SUBJ: Minutes of the 2/25/14 Meeting of the Raymond Library Expansion Project Budget Review Committee

# **AIA® Document G701™ – 2001**

## **Change Order**

<b>PROJECT (Name and address):</b>	<b>CHANGE ORDER NUMBER:</b> 006	<b>OWNER:</b> <input checked="" type="checkbox"/>
Addition and Alterations to the Raymond Library 840 Main Street, East Hartford, CT 06108	<b>DATE:</b> February 13, 2014	<b>ARCHITECT:</b> <input checked="" type="checkbox"/>
<b>TO CONTRACTOR (Name and address):</b>	<b>ARCHITECT'S PROJECT NUMBER:</b> 2012-2	<b>CONTRACTOR:</b> <input checked="" type="checkbox"/>
W. J. Mountford Company 170 Commerce Way South Windsor, CT 06074	<b>CONTRACT DATE:</b> December 3, 2013	<b>FIELD:</b> <input type="checkbox"/>
	<b>CONTRACT FOR:</b> General Construction	<b>OTHER:</b> <input checked="" type="checkbox"/>

**Raymond Library  
PCO 17**

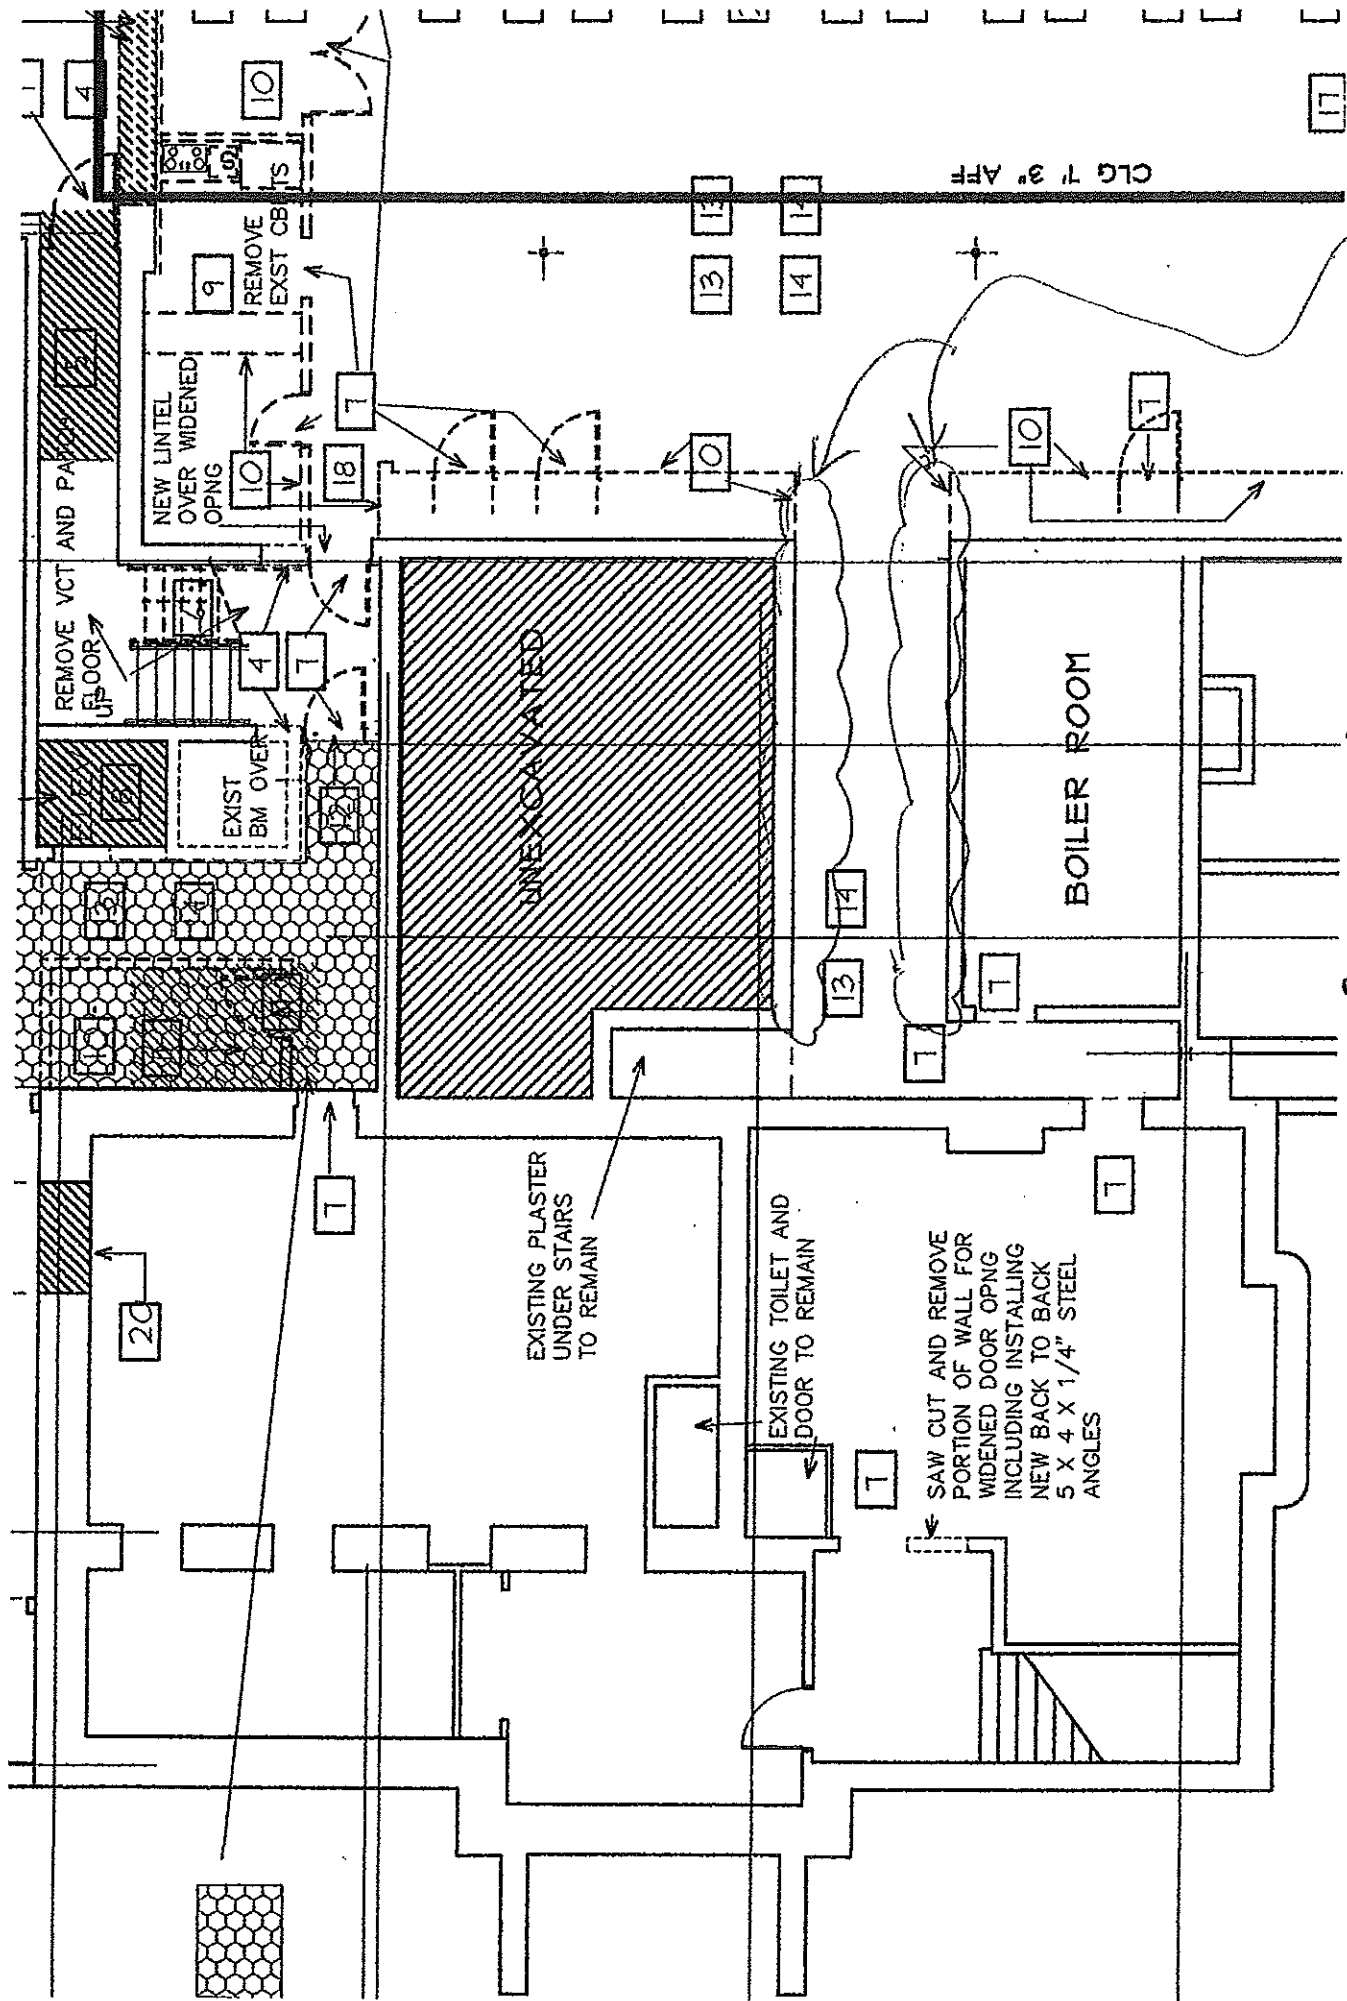
PCO #009 - Remove paneling, sheetrock and framing at the basement level walls as noted on the attached sketch and discussed at the project meeting on 1-28-14.				
--	--	--	--	--

**Description:** REMOVAL of paneling and wood 2"x4" framing in Basement Hallway. Includes removals, transportation of debris to dumpsters, disposal, and clean up of work zone. Work Completed 02/04/14.

Remove paneling & studs, etc  
back to concrete or cinder walls
